TO: Mercedes-Benz Dealer Principals, General Managers, Sales Managers, Service Managers, Parts Managers	FROM: Gregory Gunther, Department Manager, Vehicle Compliance and Analysis, Engineering Services
RE: Recall Campaign Launch Notification Wiring Harness for Electric Coolant Pump MY19 CLS-Class (257 Platform)	DATE: October 18, 2019

Campaign No. 2019090019, October 2019

SUBJECT: **Model CLS-Class vehicles (257 platform)**
Model Year 2019
Wiring Harness for Electric Coolant Pump

Figure 1

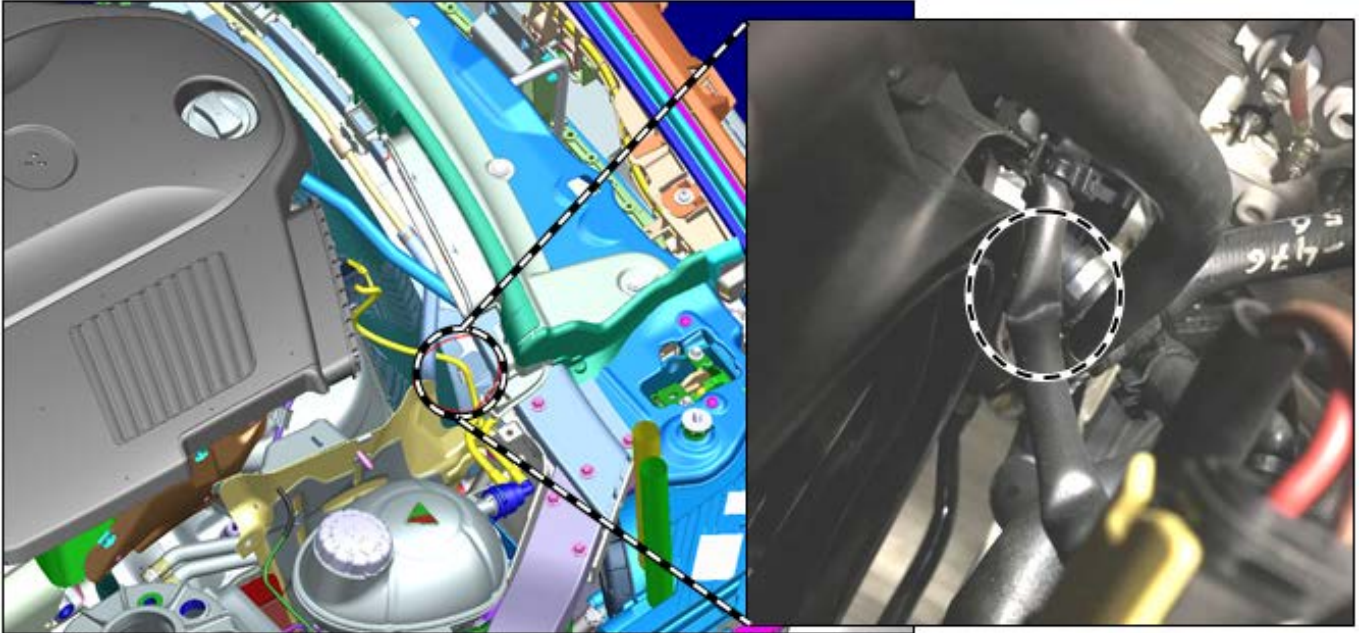
1. Check electrical wiring harness of electric coolant pump in area of fan for damage (figure 1).

- a. **Line insulation and protective hose of electrical wiring harness damaged:**
Perform **work procedures A and B and C.**
- b. **Only Protective hose of electrical wiring harness damaged and line insulation NOT damaged:**
Perform **work procedures B and C.**
- c. **Line insulation and protective hose of electrical wiring harness Both NOT damaged:** Perform **work procedure C.**
